## Schedule 17 Application for Non-Material Change – Façade Design Update Presentation Dec 2020

Document no: **1CP01-MDS-TP-REP-SS08\_SL41-000001**

WP137 LUL VENT SHAFT & SUBSTATION  
FACADE DESIGN UPDATES 201217  
WILLIAM MATTHEWS ASSOCIATES

FACADE COMPARISON

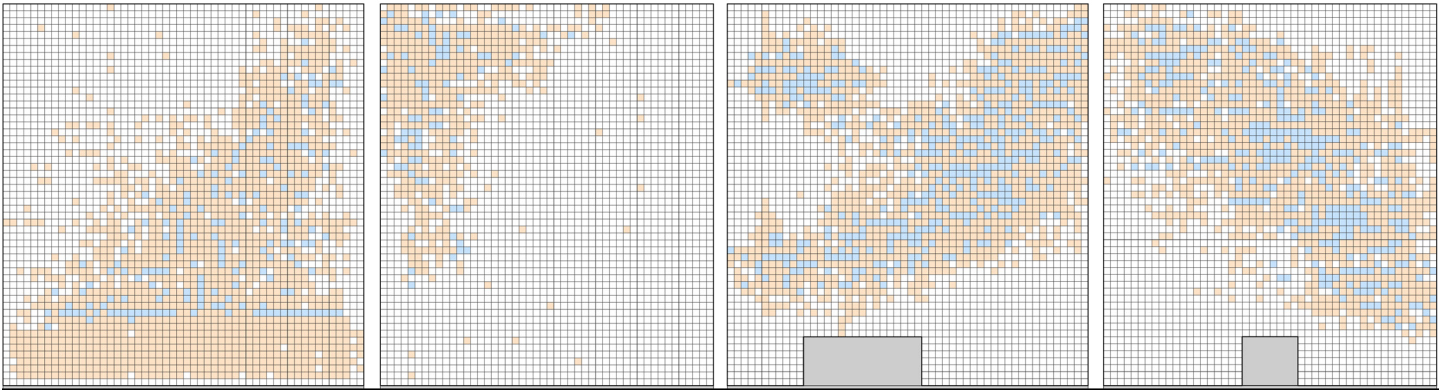
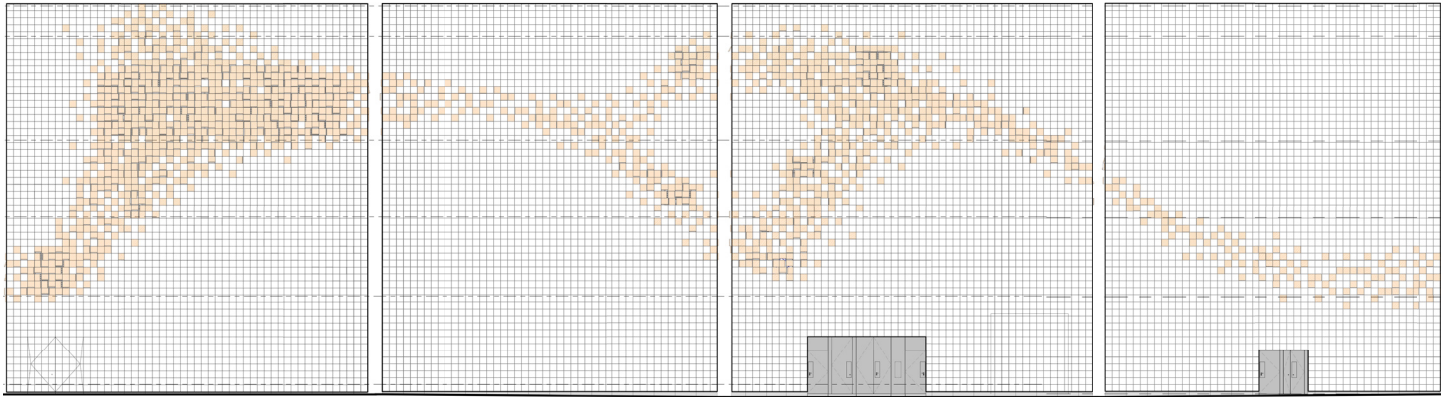
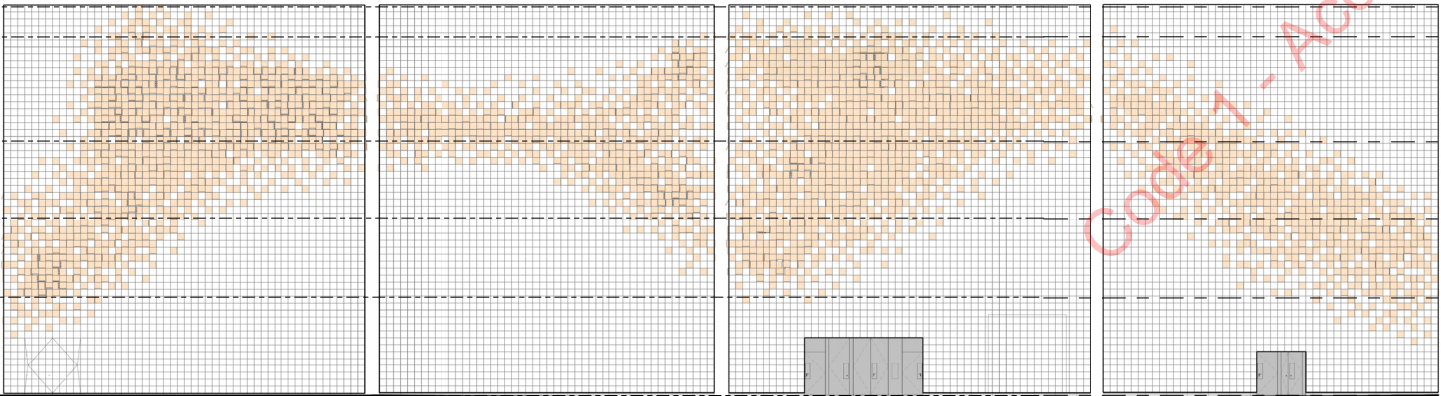
In the S17 design 40% of the tiles were either tilted or perforated, with most on the north, east and south façades – see façade comparisons on the next page. On the north façade there was a notable concentration of openings at street level, as required for the natural ventilation of the substation within. However, despite having perforations, the tiles at below 3m above street level were flush in order to not facilitate climbing or littering.

For the design presented in Summer 2020, the number of tilted tiles (NB there are no longer any perforated tiles, just flat or tilted) dropped from 40% to 15%, due to the significant reduction in the required louvred area. As a result the area of flat tiles increased accordingly, most notably on the east and west façades.

As part of this design exercise the team looked at increasing the number of tilted tiles back to 40%, as per the S17 design. However this proved unsatisfactory if the requirement of having no tilted tiles below 3m above street level was also respected. By having none at the lower levels of the façade, and therefore proportionally more higher up, the overall façade compositions looked unbalanced.

Subsequently, in the latest proposal - December 2020 - the amount of tilted tiles has been adjusted to 30% in order to create a balanced pattern and natural flow around the building. The east and west façades in particular have considerably more tilted tiles and are much closer to the S17 design.

In comparison to the Summer 2020 proposal, the December 2020 design doubles the number of tilted tiles from 15% to 30% of the overall total. The façade compositions have considerably more variation, interest and movement than before, whilst remaining balanced and in line with the original concept. As a result they are as close as possible to the approved S17 design without being an unhappy compromise.
